# AGREEMENT

*Addendum 25: Regulation No. 26 to be annexed to the Agreement*

*Amendment 1*

## UNIFORM PROVISIONS CONCERNING THE APPROVAL OF VEHICLES WITH REGARD TO THEIR EXTERNAL PROJECTIONS

Model A

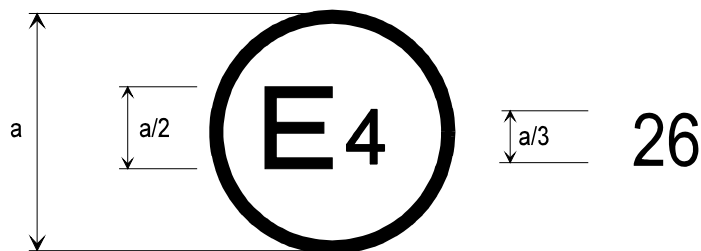
Replace Annex 2 by the following:

(See paragraph 4.4. of this Regulation)

a = 8 mm min

The above approval mark affixed to a vehicle shows that the vehicle type concerned has, with regard to external projections, been approved in the Netherlands (E 4) pursuant to Regulation No. 26.
